PCB 0D1 LS-6112P REV0 SIDE BTN/B

FPR +SAS+ BTN Board Schematics

REV 1.0 2010-06-02

Title			
COVER PAGE			
Size	Document Number		Rev 0.1
Date:	Wednesday, June 02, 2010	Sheet	1 of 3

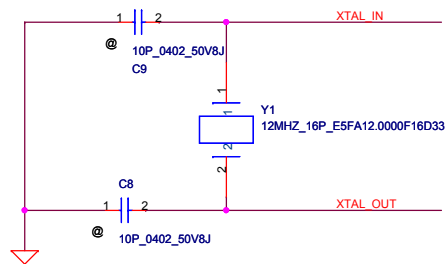
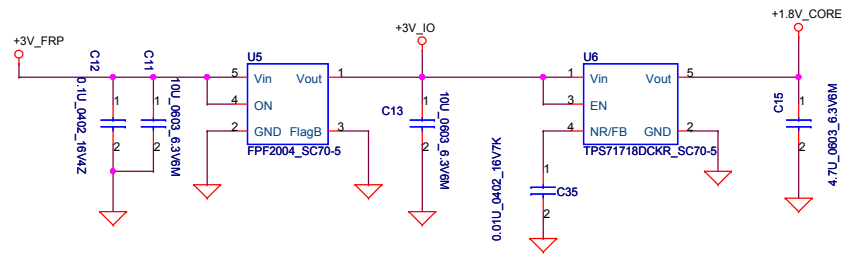
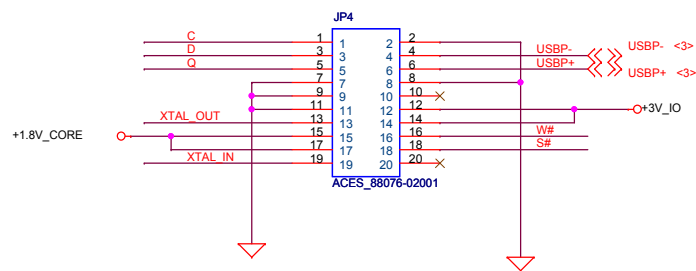
DVT change D1 to VMZ6.8N

Title			
Button			
Size	Document Number	Rev	
Custom	<Doc>	<RevCode>	
Date:	Wednesday, June 02, 2010	Sheet	3 of 3

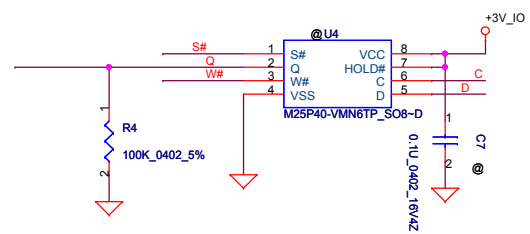
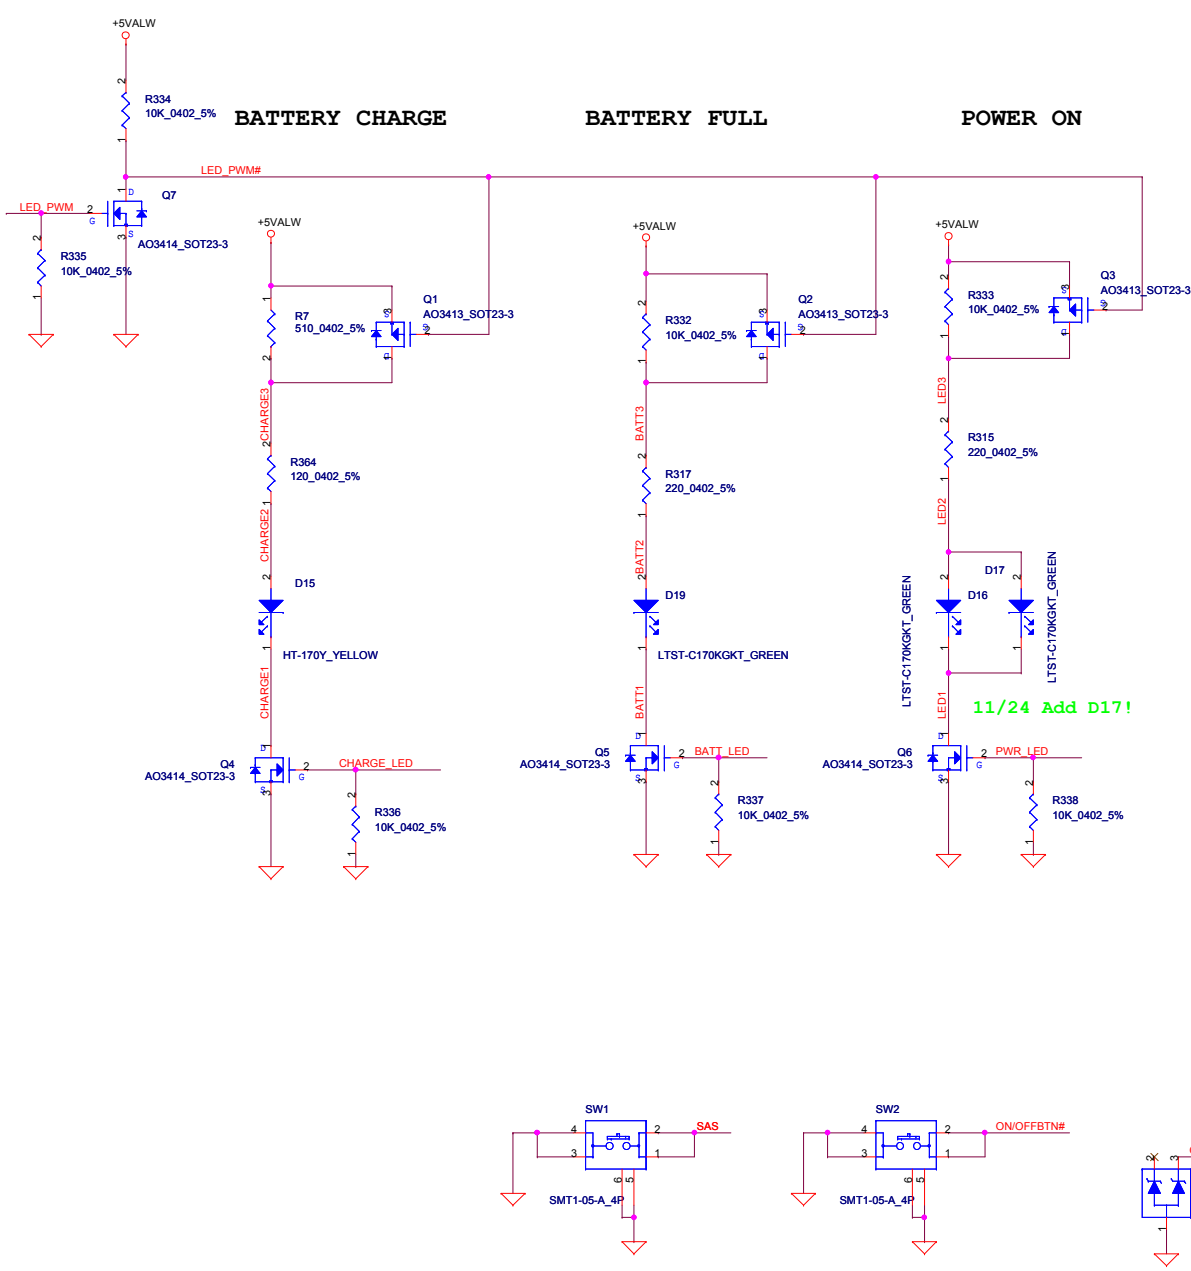
DVT2 move to FPR board!

### Connect to M/B

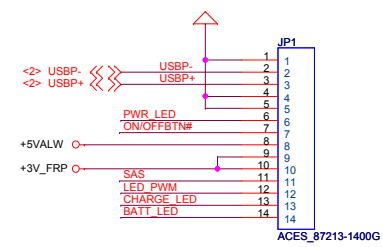
DVT change to 14 Pin wire

DVT add this diode!

PVT change to SN100000W00!
